ADDENDUM NO. 2
SEWER SYSTEM IMPROVEMENTS
CONTRACT 17-01
MORNINGSIDE DRIVE 8-INCH FORCE MAIN
CHAPEL HILL, TENNESSEE
WAUFORD PROJECT NUMBER 2034
CDBG PROJECT NO. 11132

Date of Addendum: Thursday, July 5, 2018
Bid Opening: To Be Determined

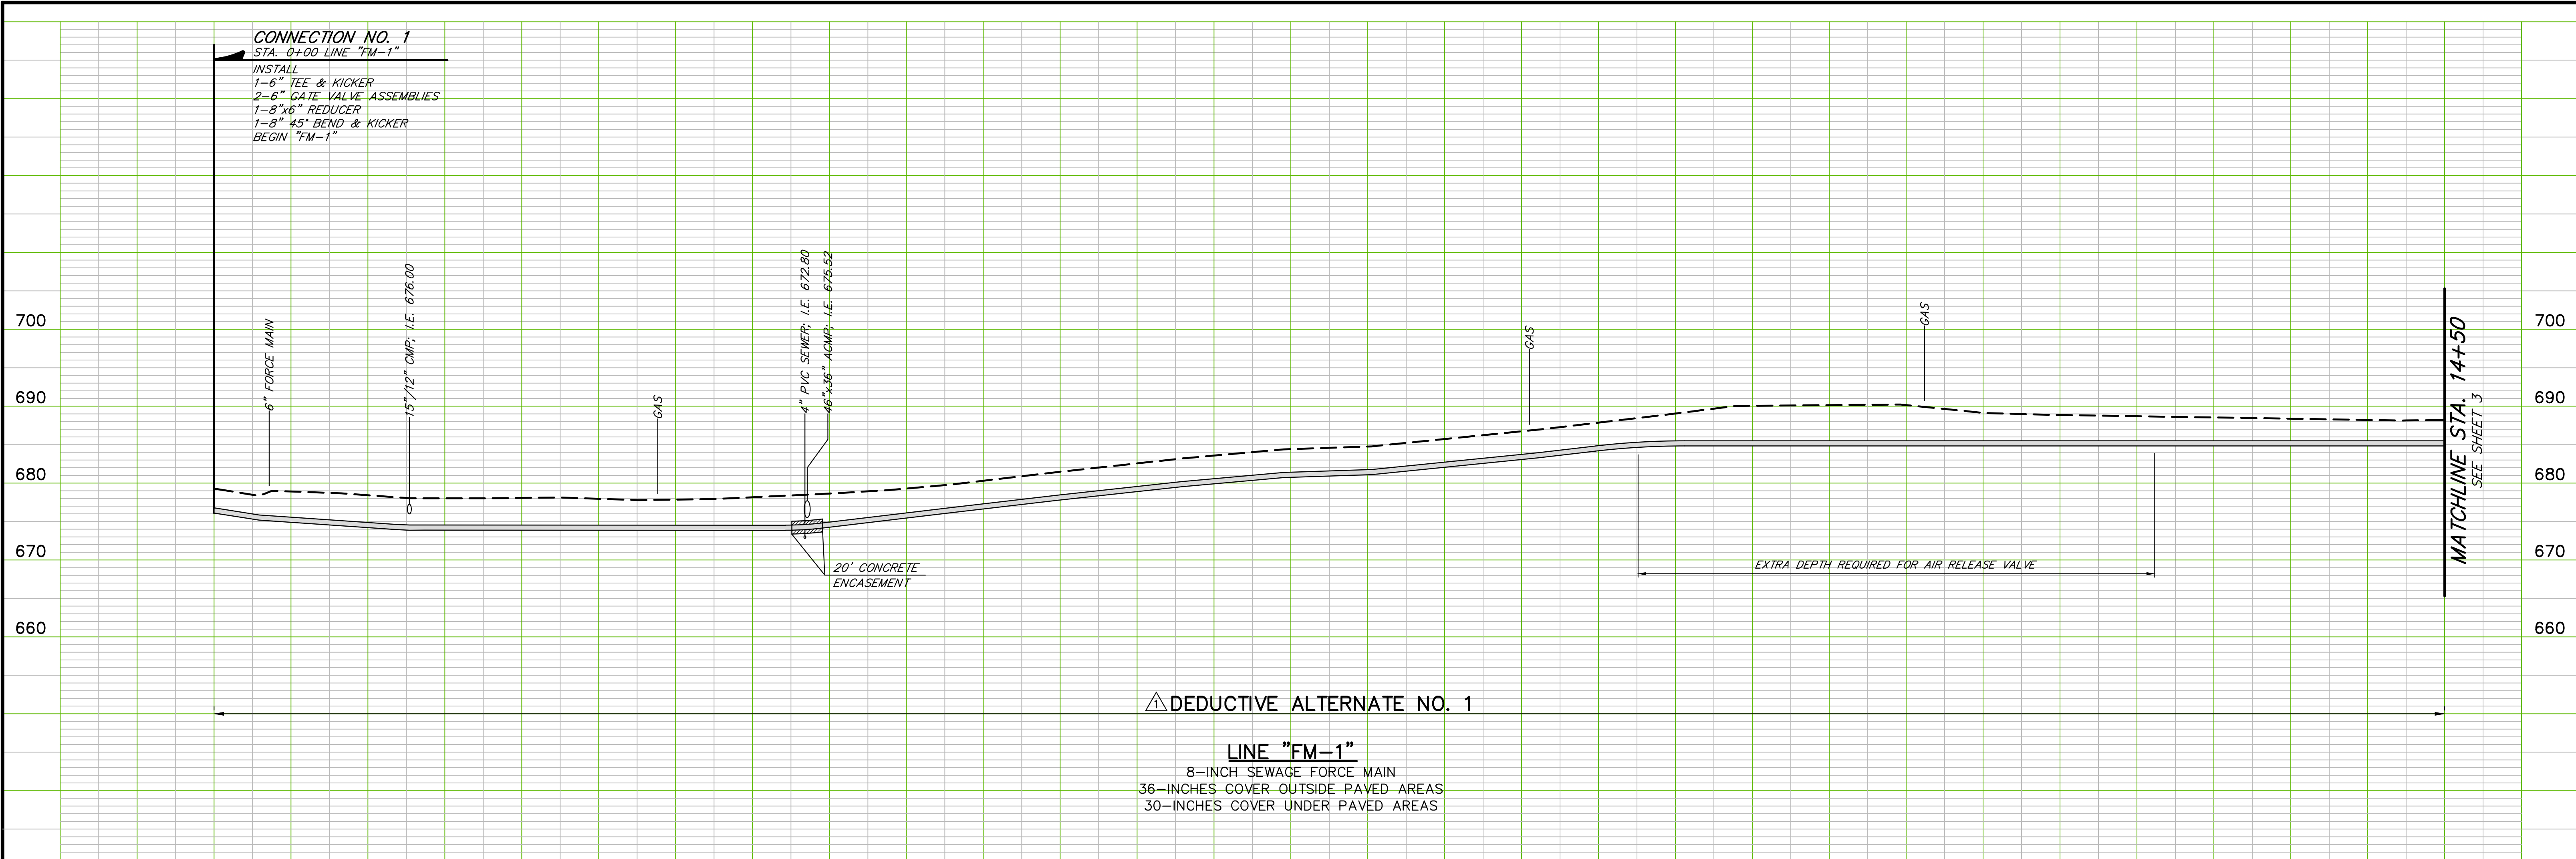
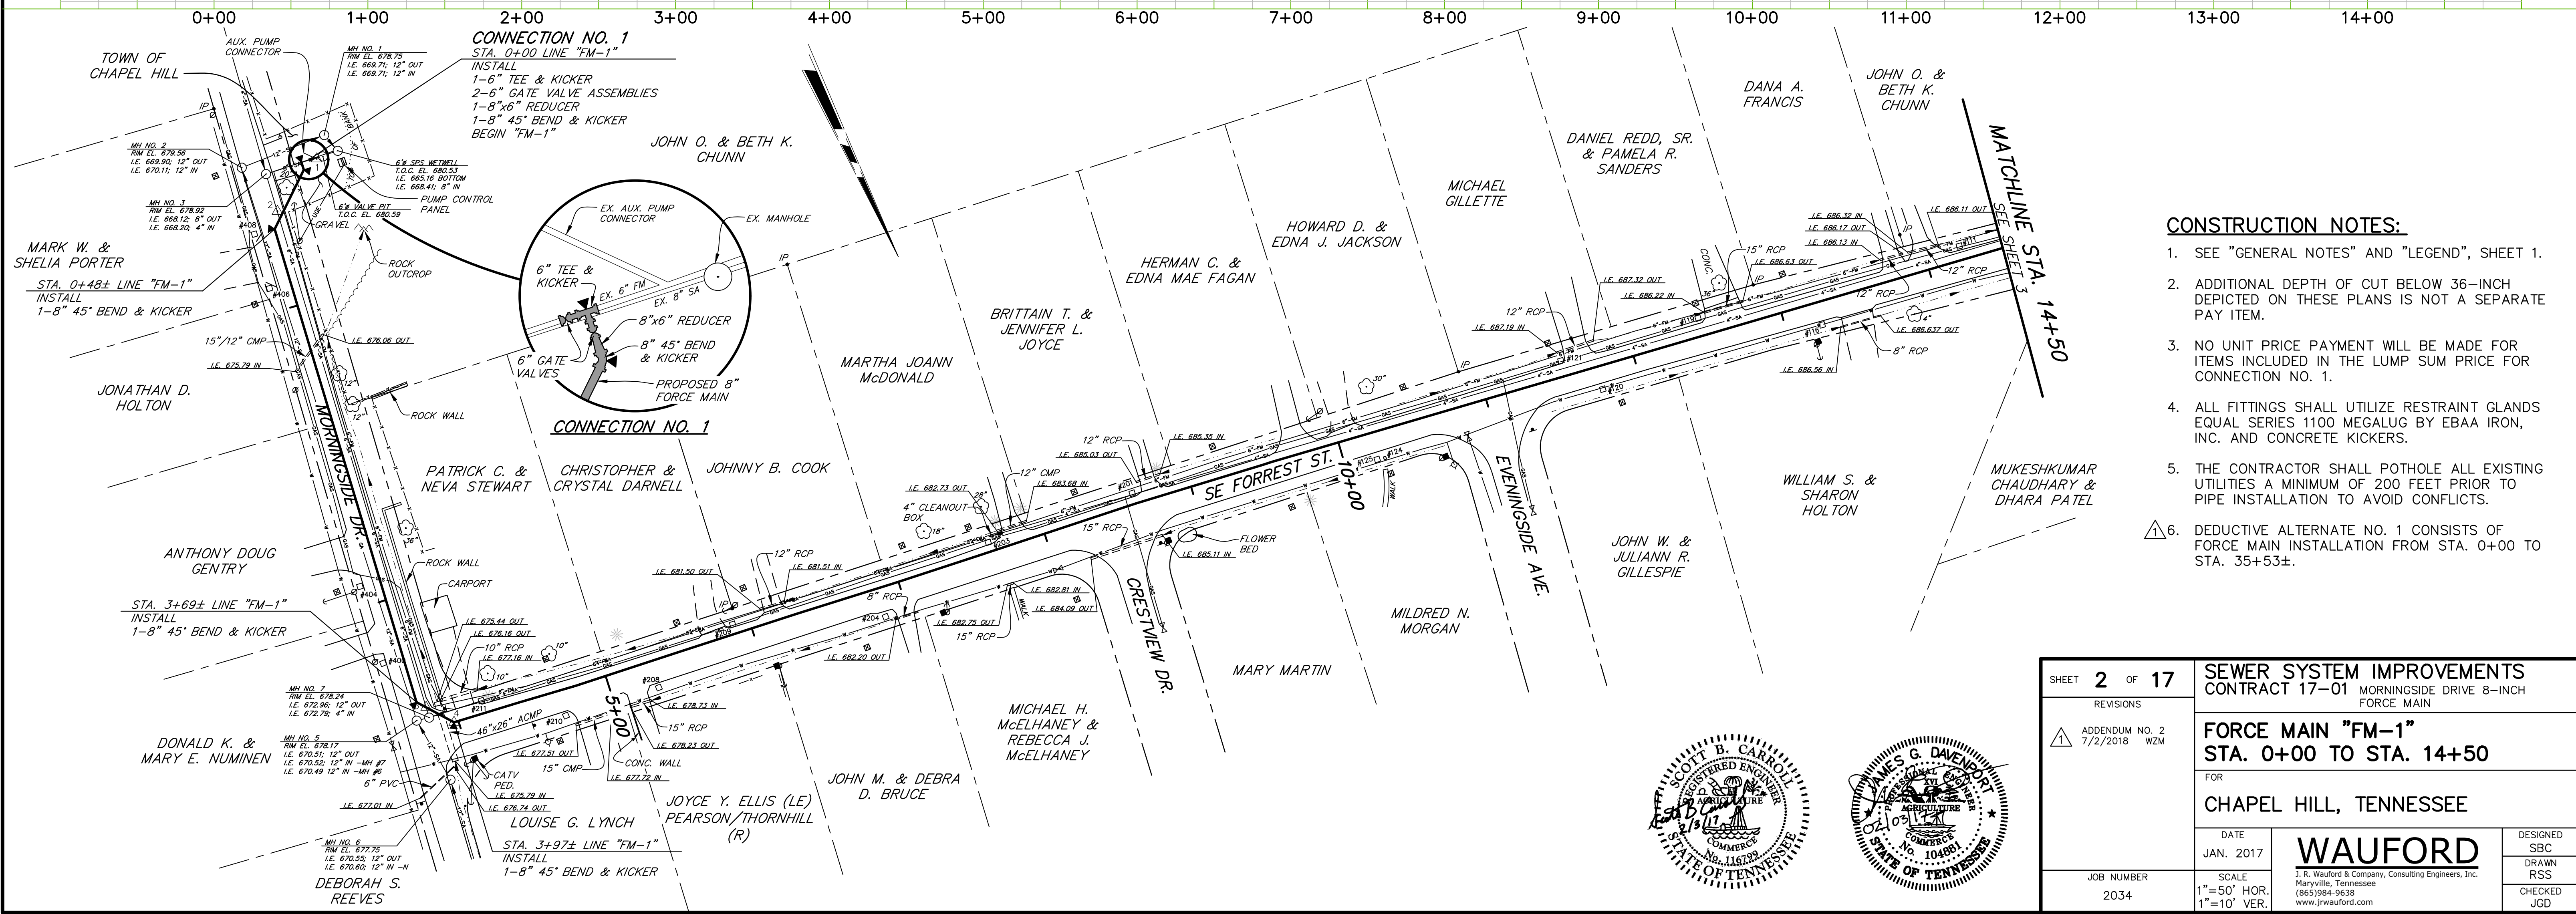
1. BID FORM:
Replace the entire BID FORM with the attached BID FORM.
2. PLANS, Sheet 2:
Modify as shown on the attached 24" x 36" sheet.
3. PLANS, Sheet 3:
Modify as shown on the attached 24" x 36" sheet.
4. PLANS, Sheet 4:
Modify as shown on the attached 24" x 36" sheet.

△ DEDUCTIVE ALTERNATE NO. 1

- CONSTRUCTION NOTES:**
1. SEE "GENERAL NOTES" AND "LEGEND", SHEET 1.
 2. ADDITIONAL DEPTH OF CUT BELOW 36-INCH DEPICTED ON THESE PLANS IS NOT A SEPARATE PAY ITEM.
 3. NO UNIT PRICE PAYMENT WILL BE MADE FOR ITEMS INCLUDED IN THE LUMP SUM PRICE FOR CONNECTION NO. 1.
 4. ALL FITTINGS SHALL UTILIZE RESTRAINT GLANDS EQUAL SERIES 1100 MEGALUG BY EBAA IRON, INC. AND CONCRETE KICKERS.
 5. THE CONTRACTOR SHALL POTHOLE ALL EXISTING UTILITIES A MINIMUM OF 200 FEET PRIOR TO PIPE INSTALLATION TO AVOID CONFLICTS.
 - △ 6. DEDUCTIVE ALTERNATE NO. 1 CONSISTS OF FORCE MAIN INSTALLATION FROM STA. 0+00 TO STA. 35+53±.

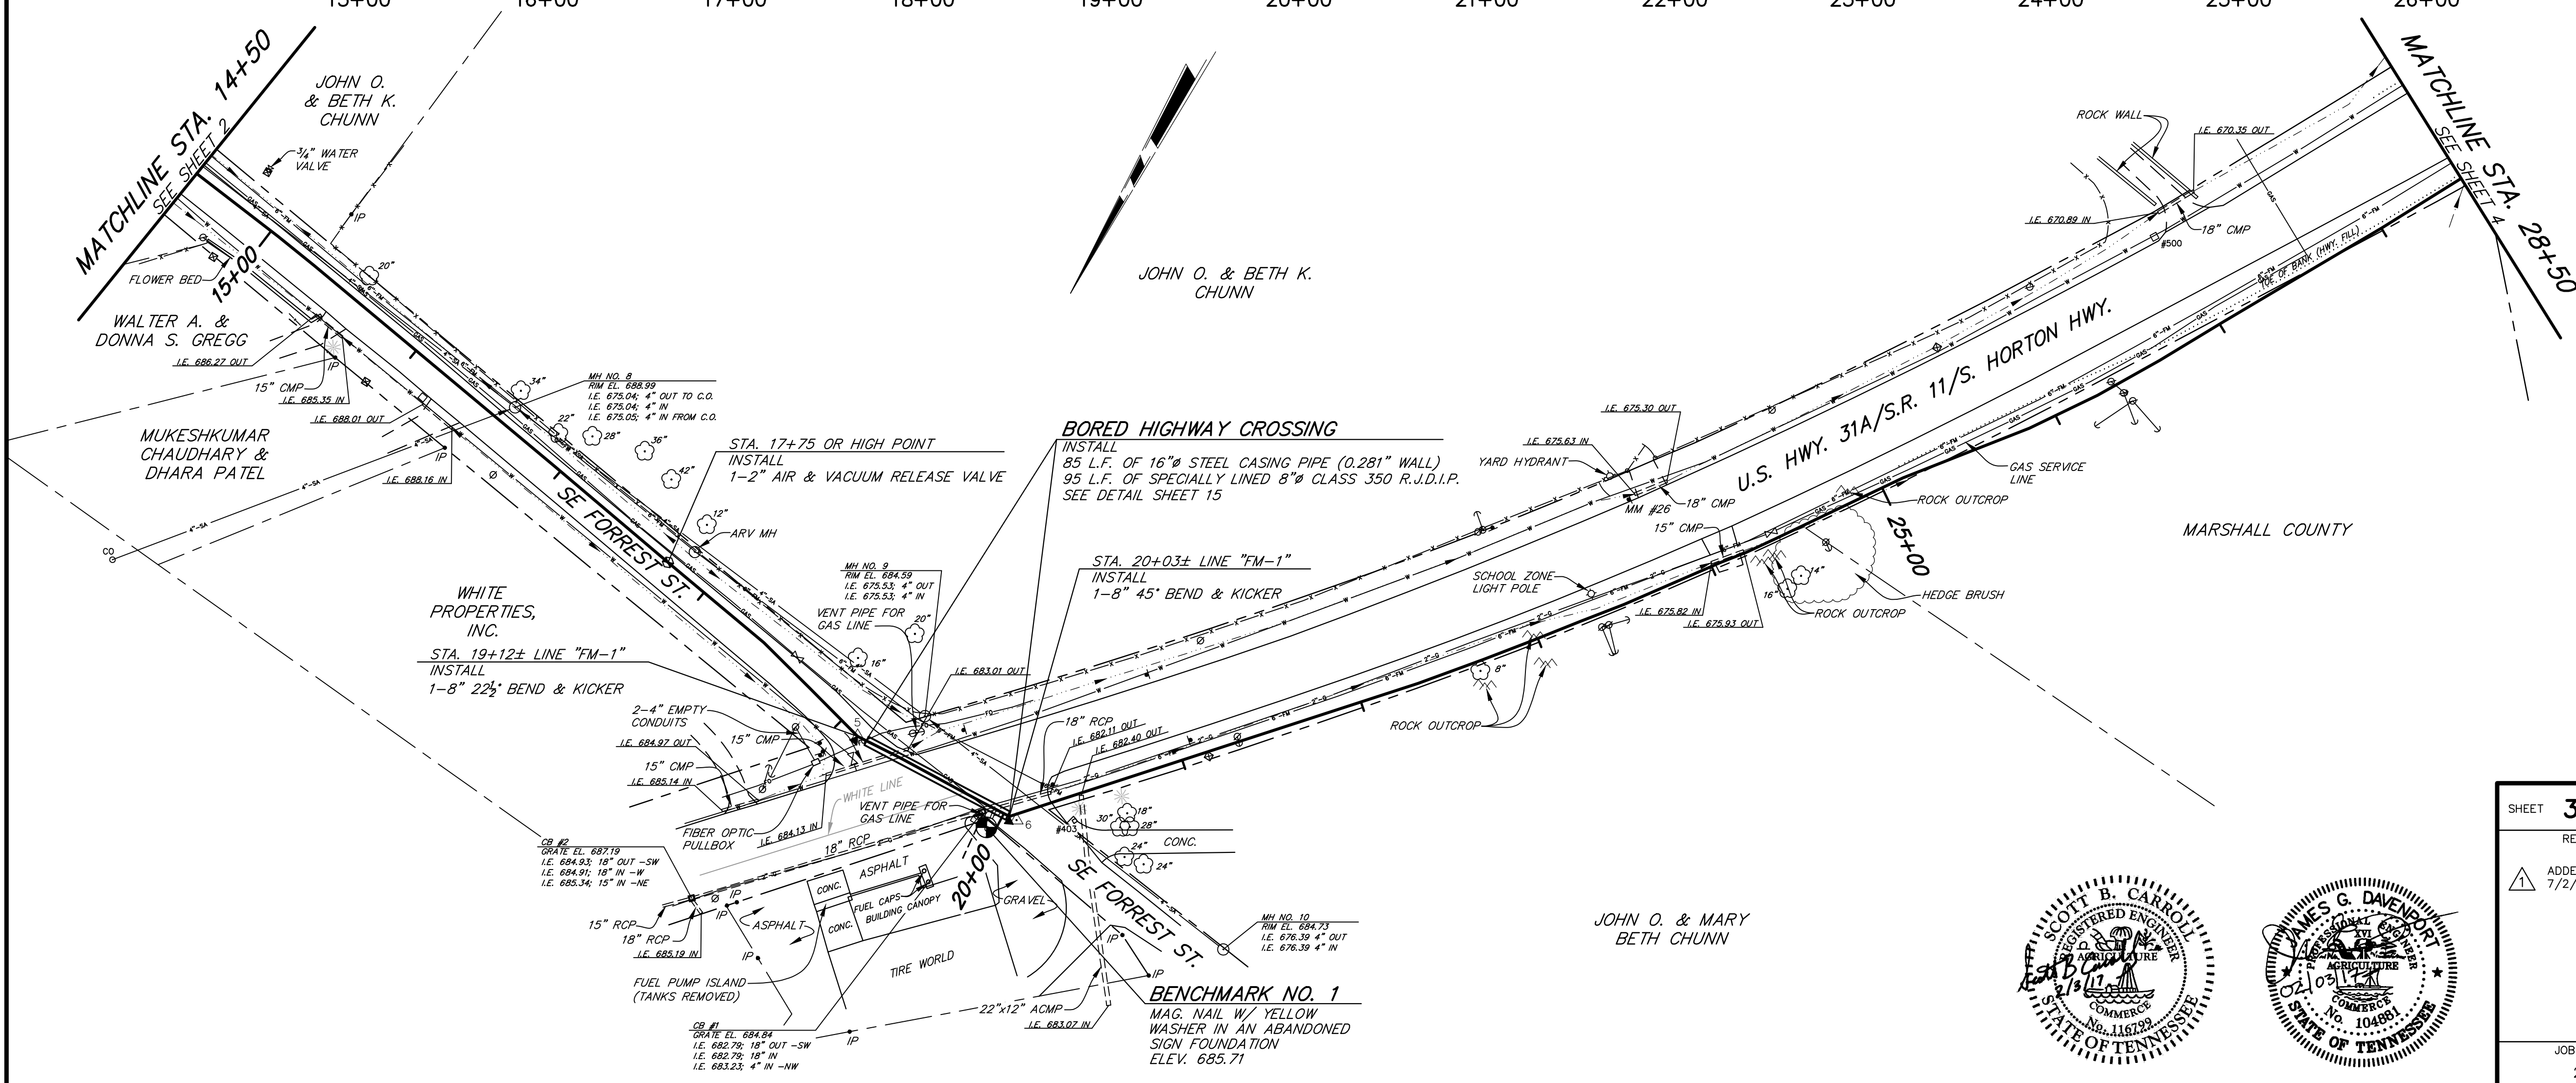
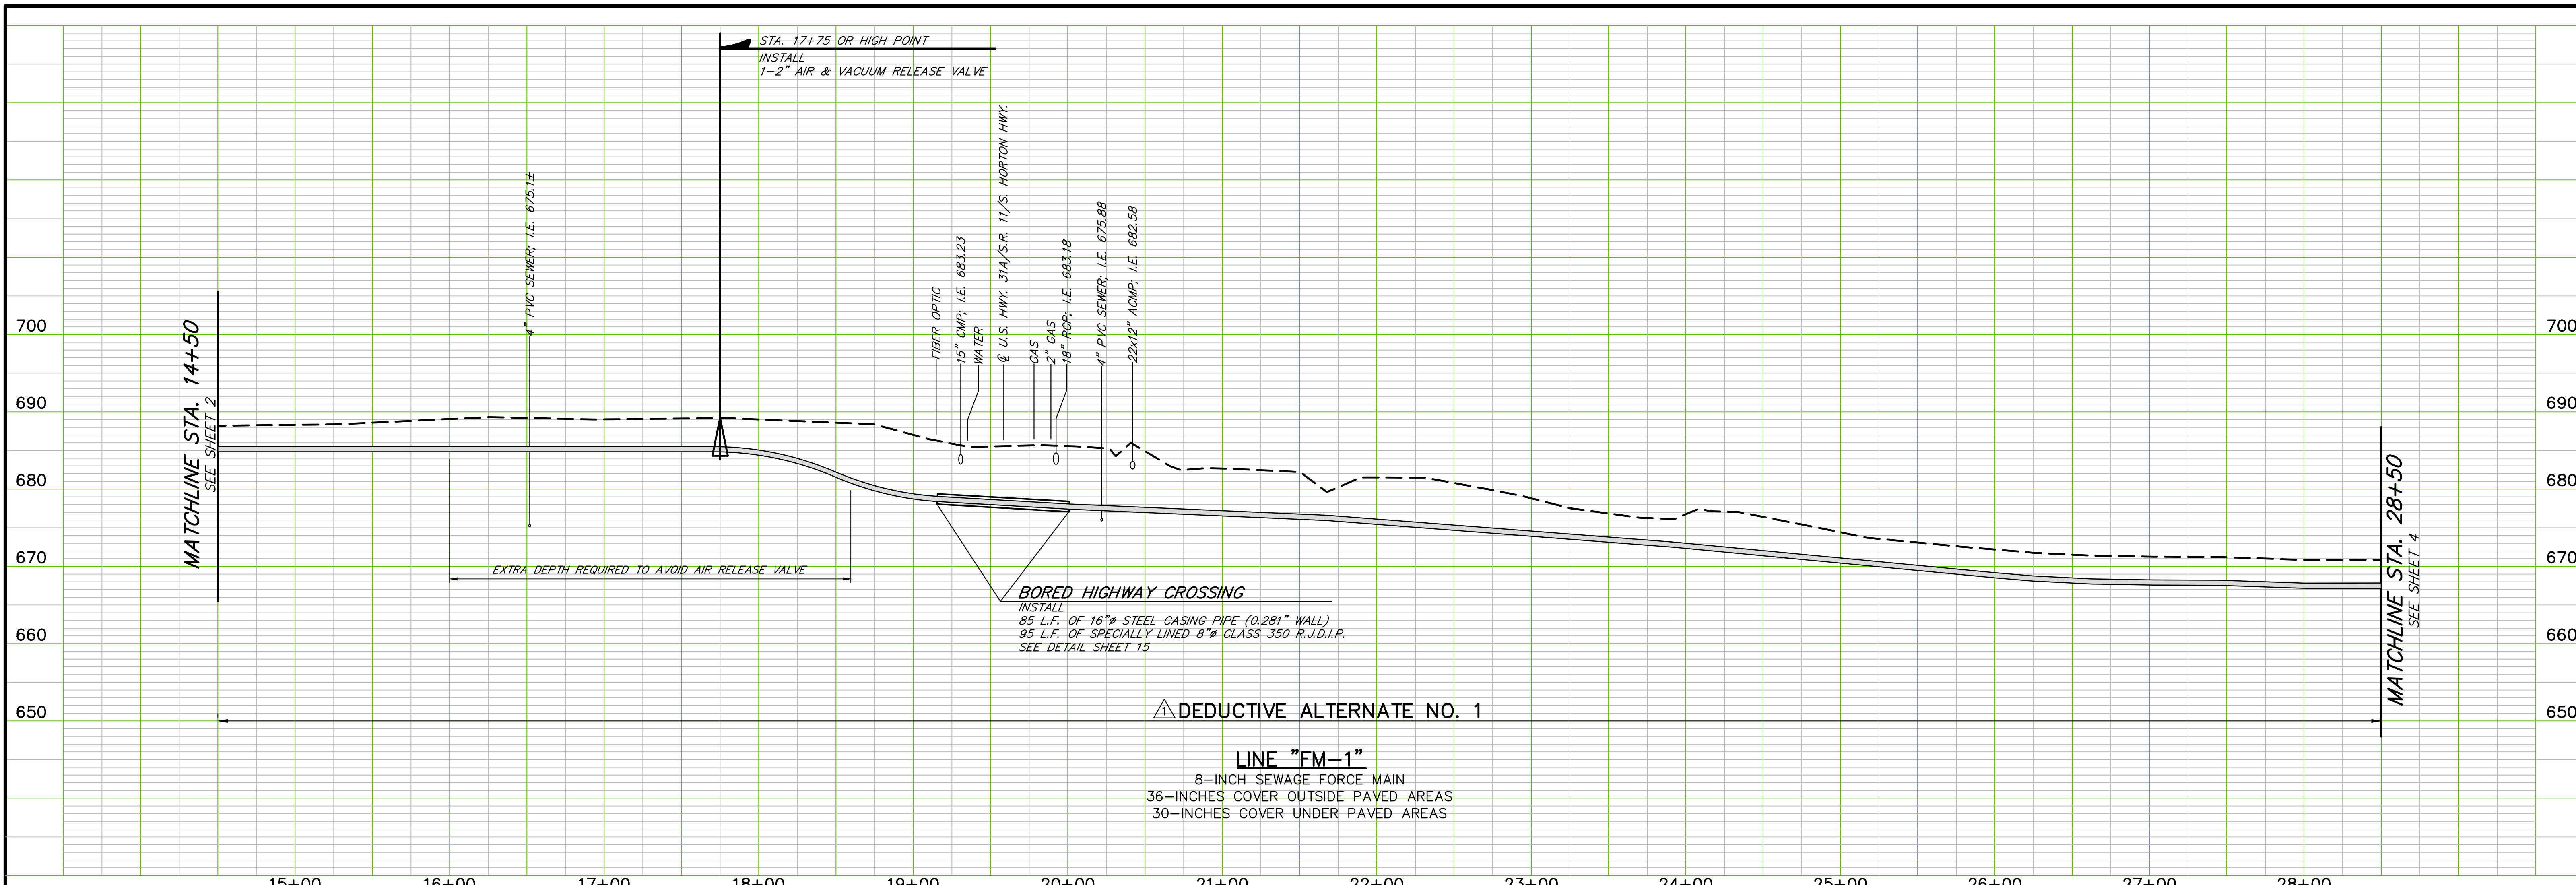
J. R. WAUFORD & COMPANY,
CONSULTING ENGINEERS, INC.

- CONSTRUCTION NOTES:**
- SEE "GENERAL NOTES" AND "LEGEND", SHEET 1.
 - ADDITIONAL DEPTH OF CUT BELOW 36-INCH DEPICTED ON THESE PLANS IS NOT A SEPARATE PAY ITEM.
 - ALL FITTINGS SHALL UTILIZE RESTRAINT GLANDS EQUAL SERIES 1100 MEGALUG BY EBAA IRON, INC. AND CONCRETE KICKERS.
 - THE CONTRACTOR SHALL POTHOLE ALL EXISTING UTILITIES A MINIMUM OF 200 FEET PRIOR TO PIPE INSTALLATION TO AVOID CONFLICTS.
 - DEDUCTIVE ALTERNATE NO. 1 CONSISTS OF FORCE MAIN INSTALLATION FROM STA. 0+00 TO STA. 35+53±.
